EFFECTIVE FIRST DAY OF THE COVER MONTH UNLESS OTHERWISE NOTED | January 2007

## BOARD OF DIRECTORS' MINUTES

**BOARD OF DIRECTORS' MINUTES | SPORTS CAR CLUB OF AMERICA, INC. | December 8, 2006**

**FIGURE 1**

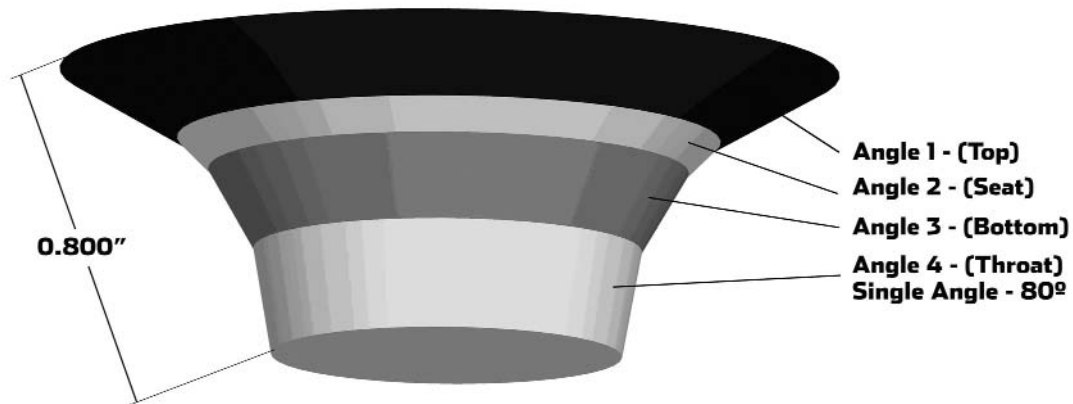
- ~~1. Direct replacement high volume/pressure oil pumps may be fitted provided that no modification to the engine is required for their installation. Alternate oil pump drive shafts may be fitted.~~

FIGURE 1

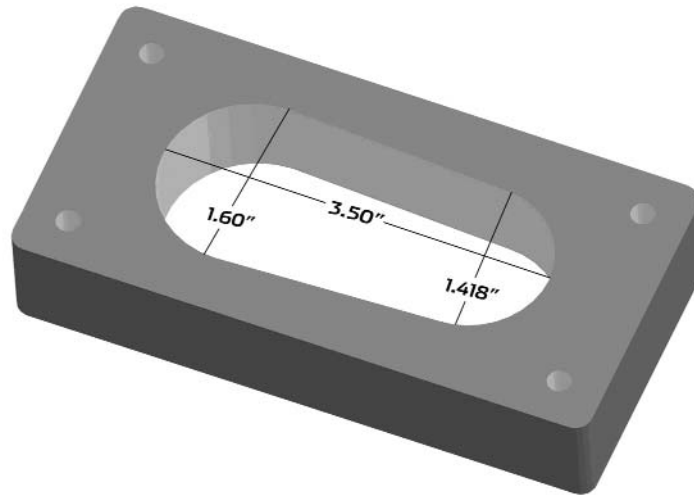
Maximum size at carburetor flange: ~~3.060" x 1.389"~~ See Figure 1

~~The diameter of the ports on the updated engine may exceed the above listed dimensions if the casting bore is untouched and in its original state.~~
